**project.** Sherwood Library Renovation | 1225 Wonderland Rd N, London, ON

**project no.** 23-006

This Addendum is issued before the award of Contract to inform the Contractor of certain modifications to the work described in the Drawings and Specifications dated September 18, 2024.

end of addendum | 001

Project No:  
 23-006  
 Sheet No:  
 ICC-202

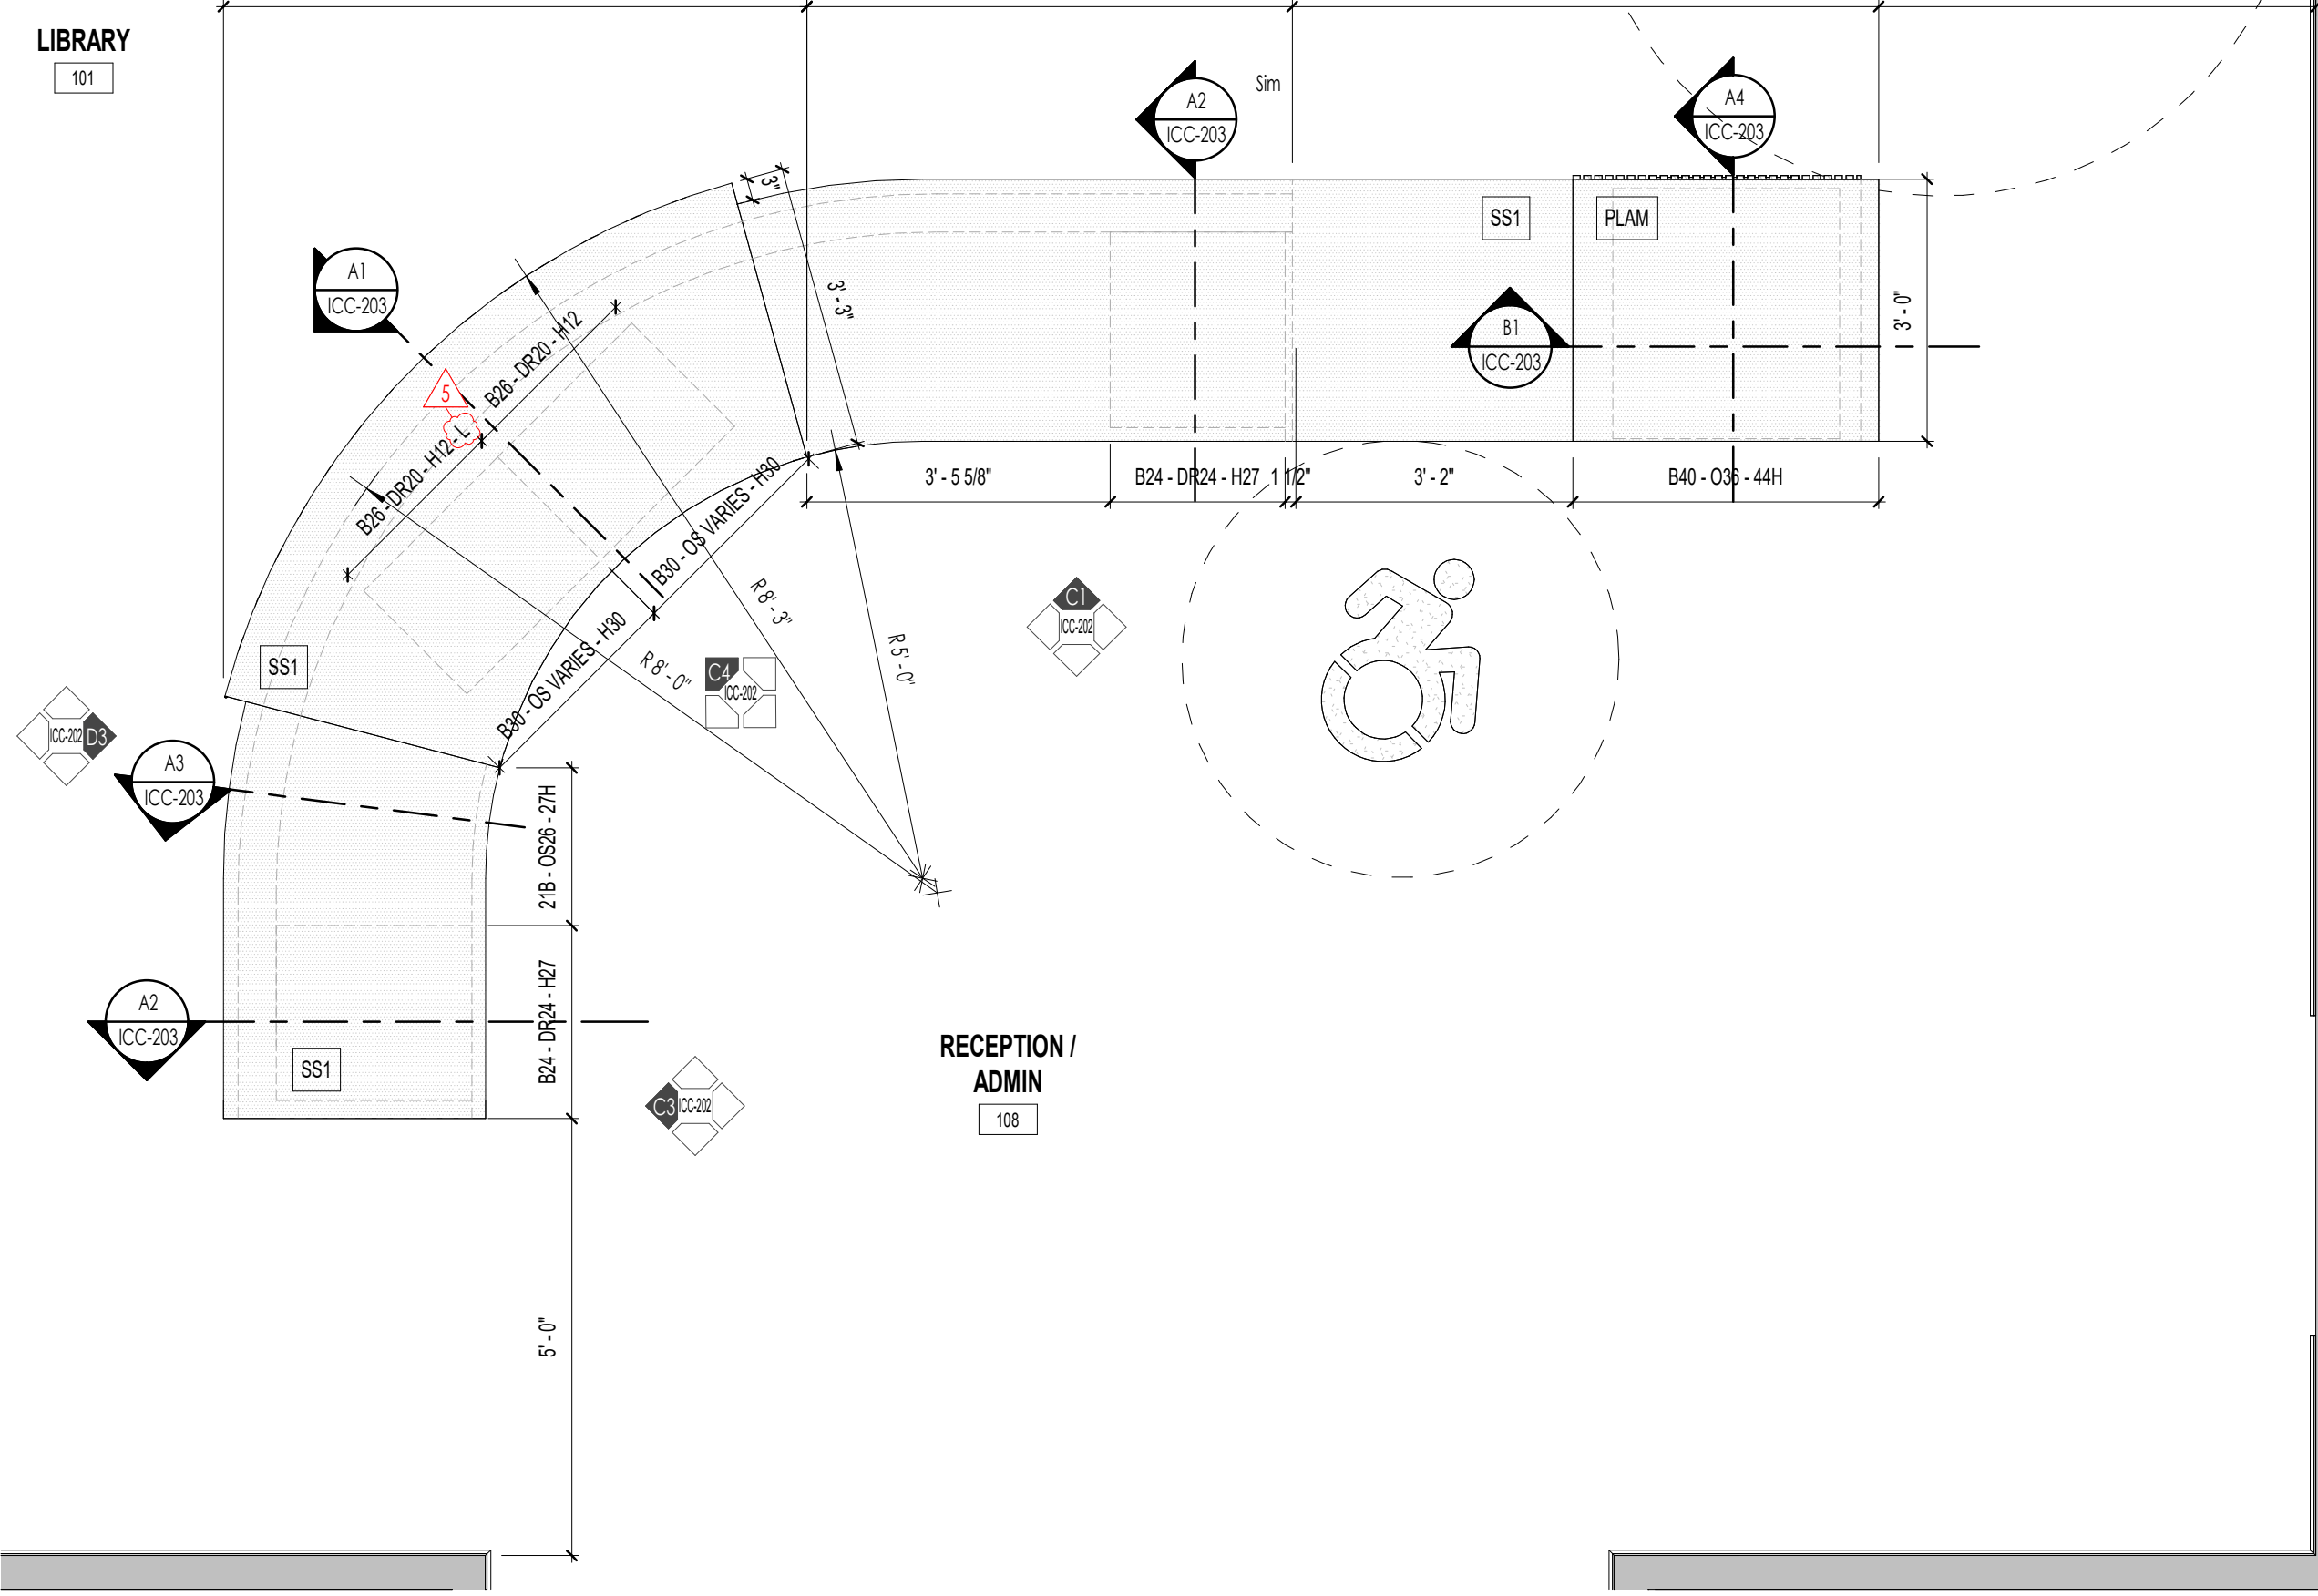
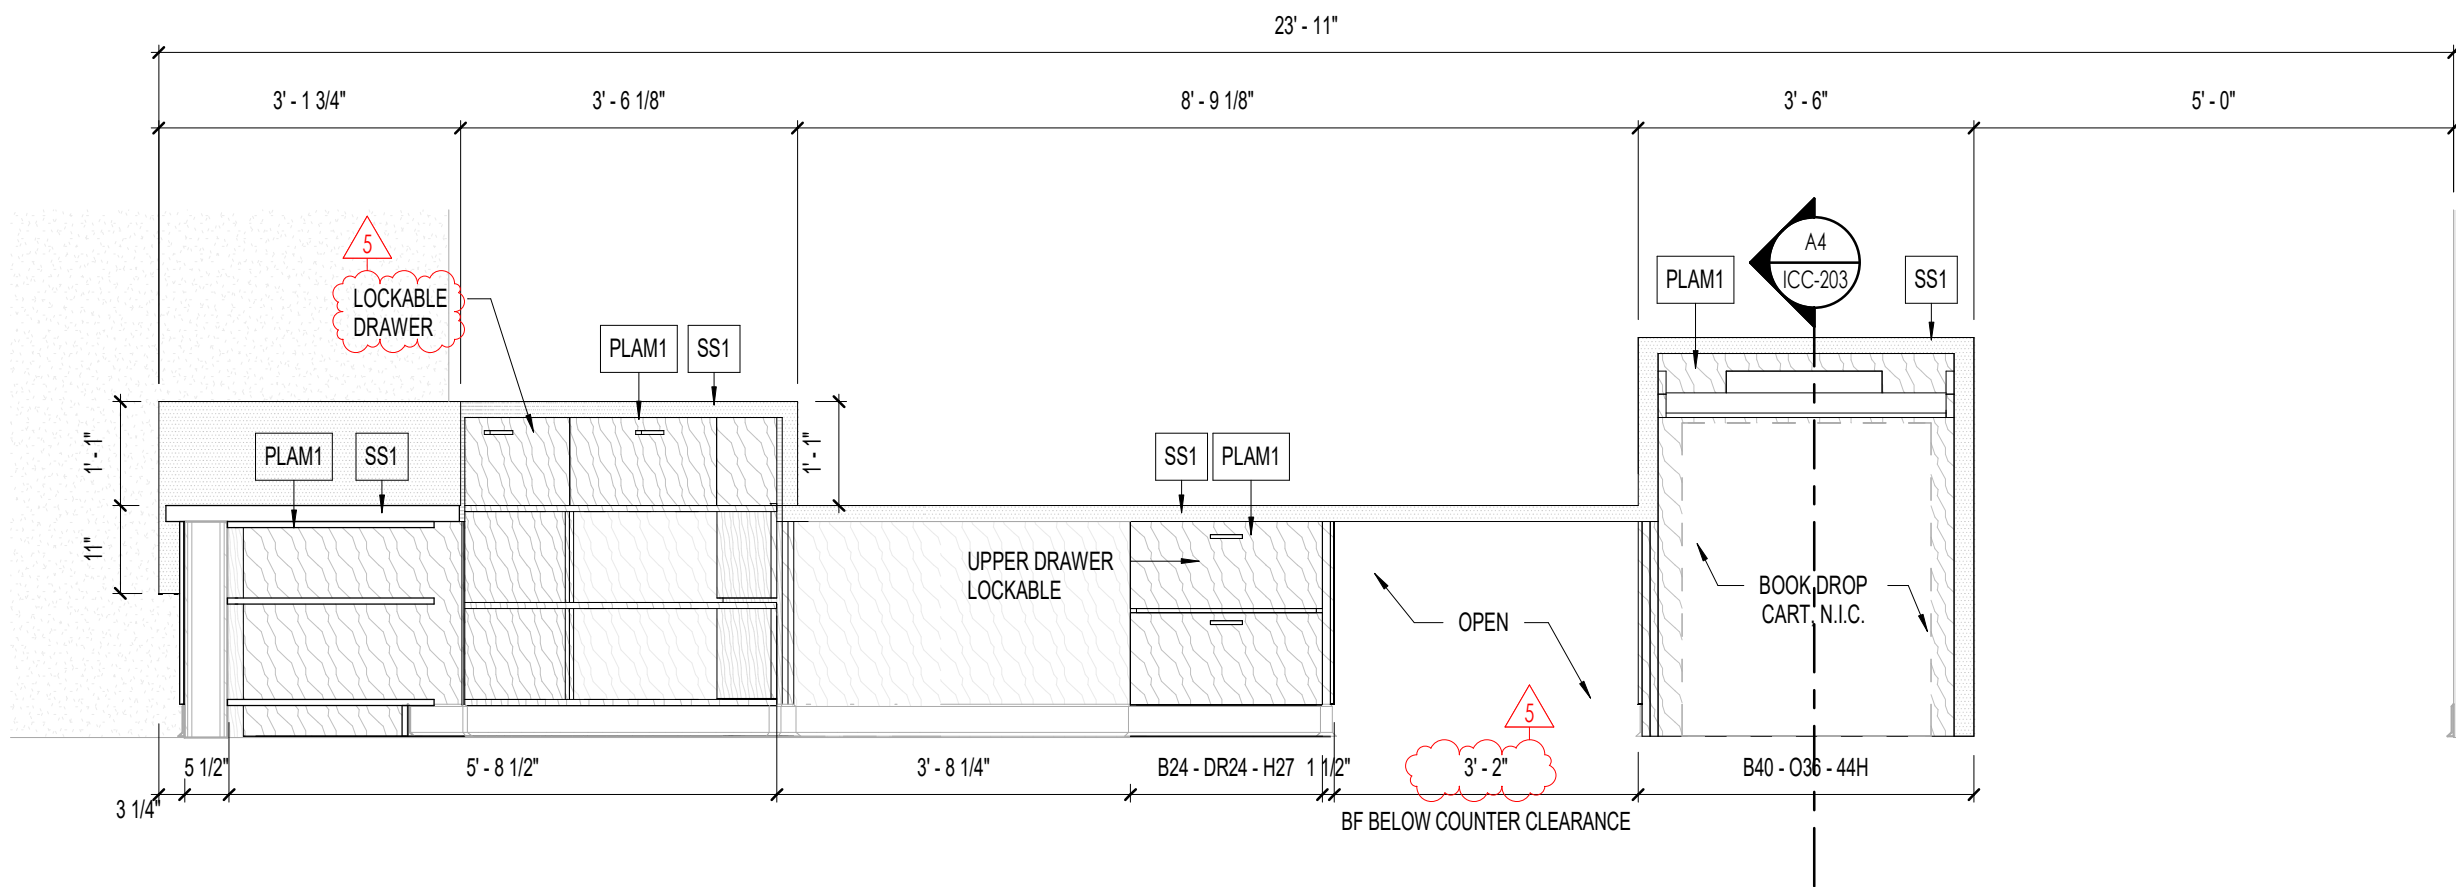
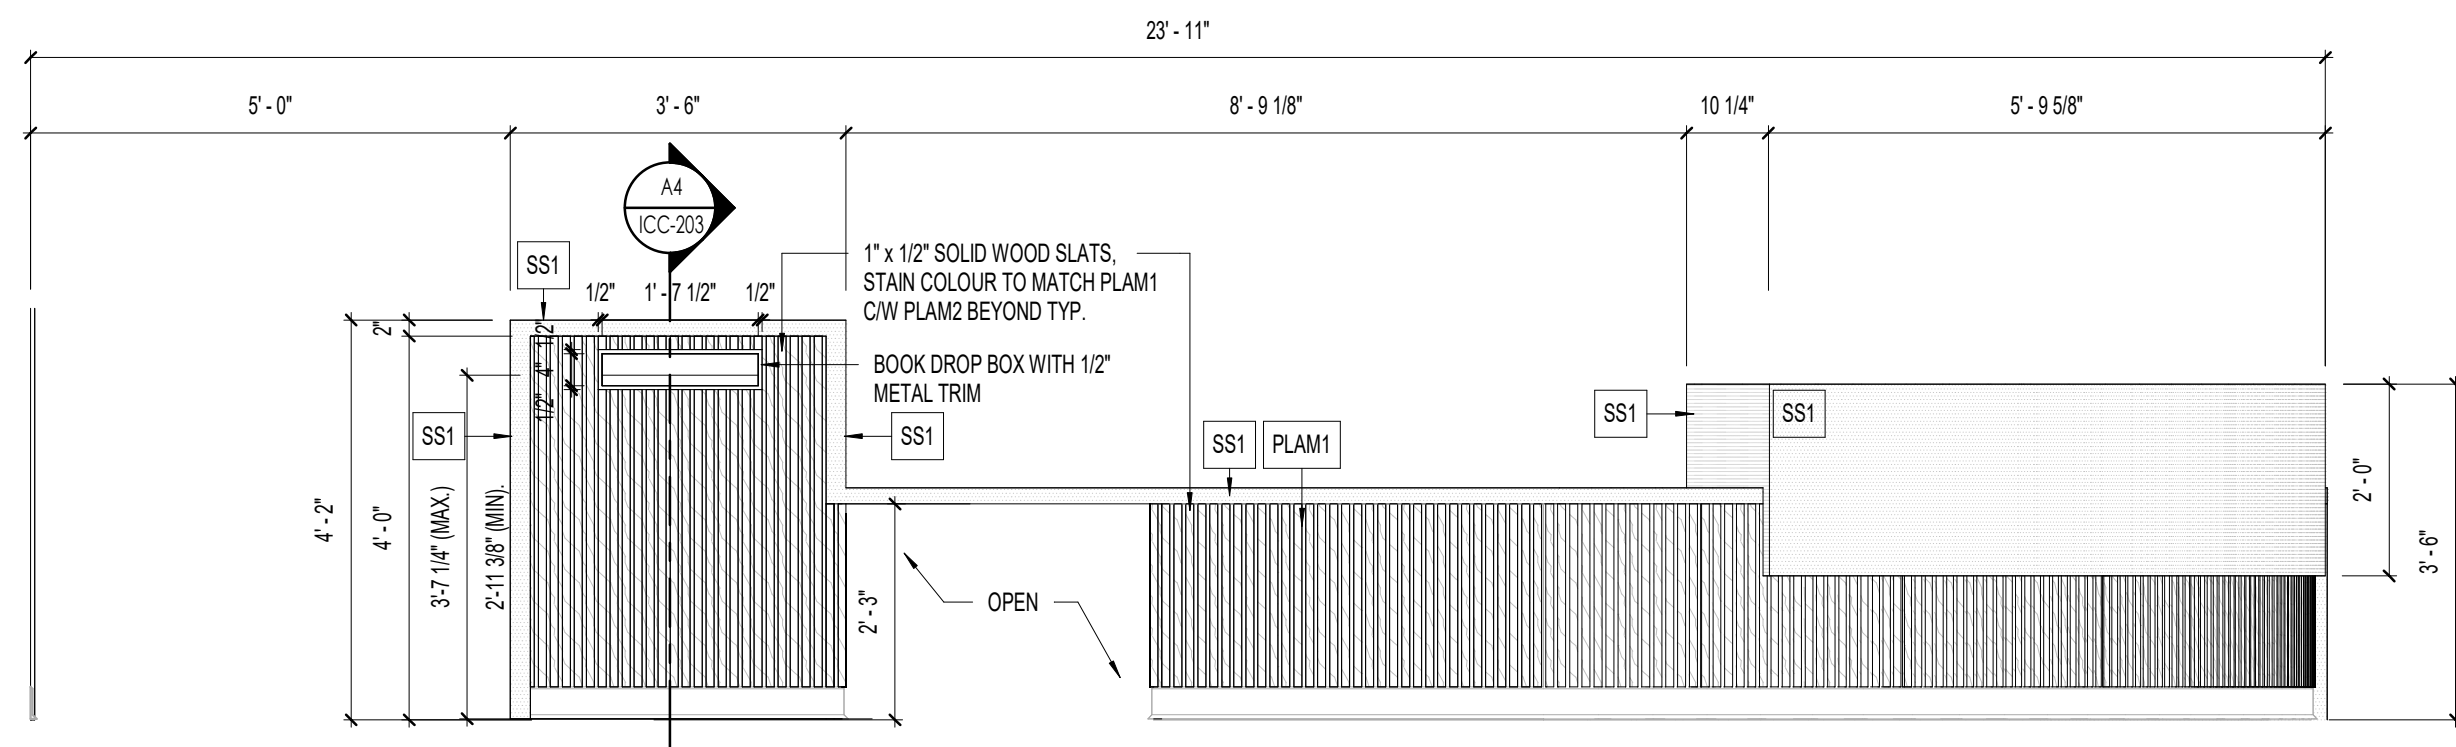
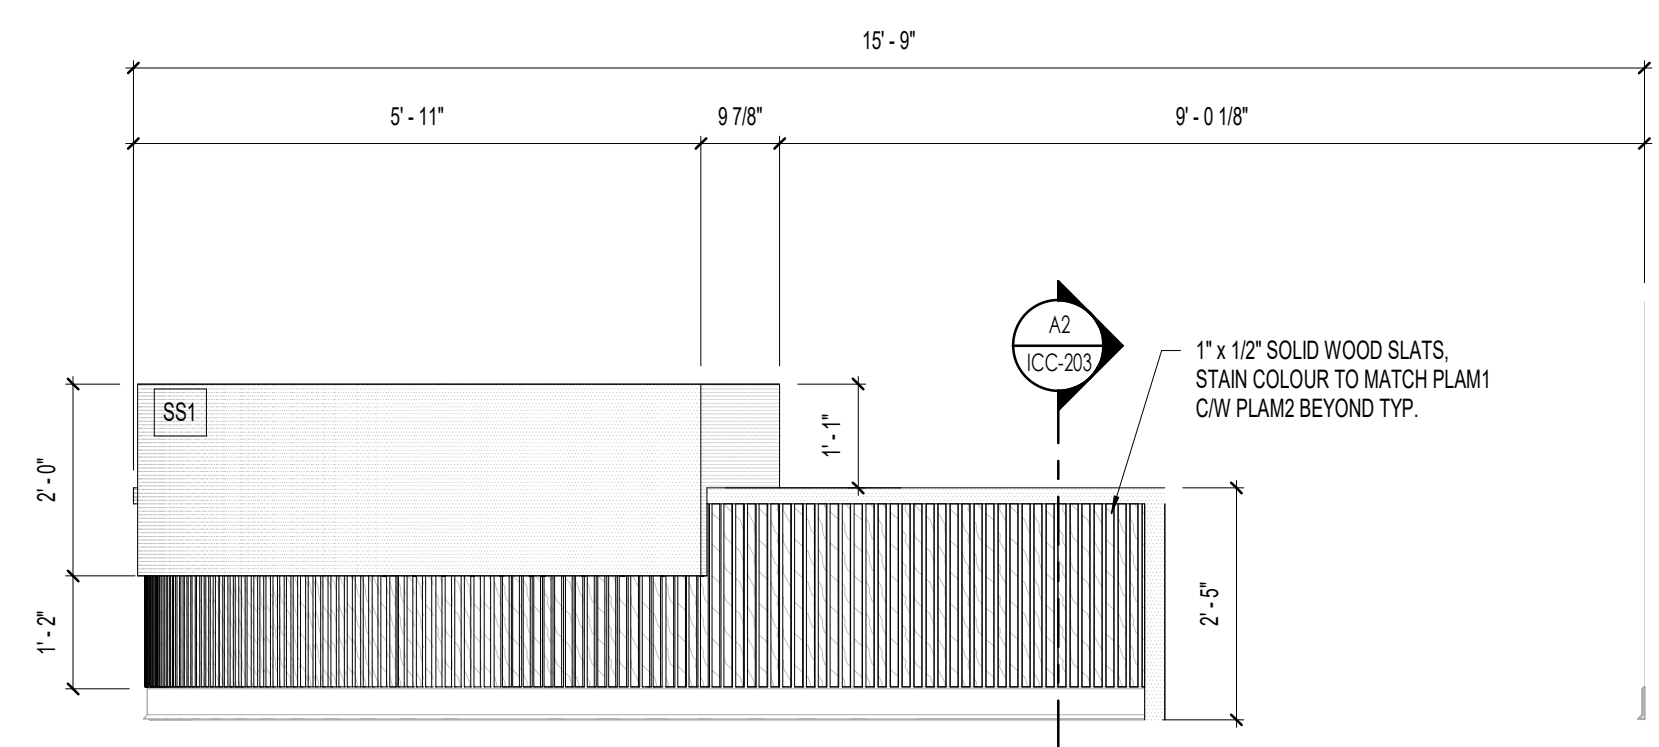
3.4 ICC-202 MILLWORK PLANS & ELEVATIONS

Refer to attached ICC-202.  
**Revise location of lockable drawer location at the reception/admin desk as follows:**
